In the Matter of)	
)	Docket Nos. 50-338 SP
VIRGINIA ELECTRIC AND POWER COMPANY)	50-339 SP
)	
(North Anna Power Station,)	(Proposed Amendment to
Units 1 and 2))	operating license NPF-4)

POTOMAC ALLIANCE RESPONSES TO THE NRC STAFF'S
INTERROGATORIES AND REQUEST FOR THE PRODUCTION OF DOCUMENTS

Contention 3: Missile Accidents

Consider the following diagram:

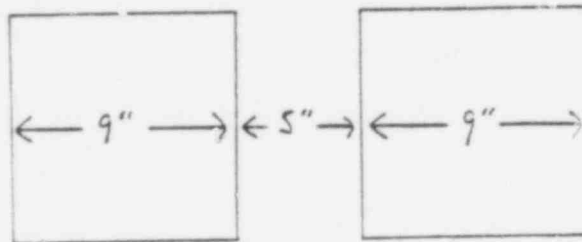
3-7 The basis for the claim in Contention 3 that the proposed modification will increase both the likelihood and the consequences of an accident involving missiles is the fact that storing the spent fuel assemblies closer together (i.e. with 14" center spacing rather than 21" center spacing) will increase:

- (a) the probability that a missile entering the pool area will strike one or more of the assemblies and
- (b) the probability that more than one assembly will be struck by any given missile entering the pool area

Assuming one of the missile entry angles with least potential for striking one or more fuel assemblies, namely a vertical angle of entry, it is obvious that in the original pool design such a missile angle could conceivably result in no fuel assemblies being struck, or at most one assembly if no deflection should occur. The new pool design would, however, make it exceedingly difficult for even a perfectly vertical missile entering the fuel assembly storage configuration to avoid striking more than one assembly. The same line of reasoning would apply to a missile entering at an "optimum" angle of approach: the consequences would be increased even further as the angle of approach nears the "optimum".
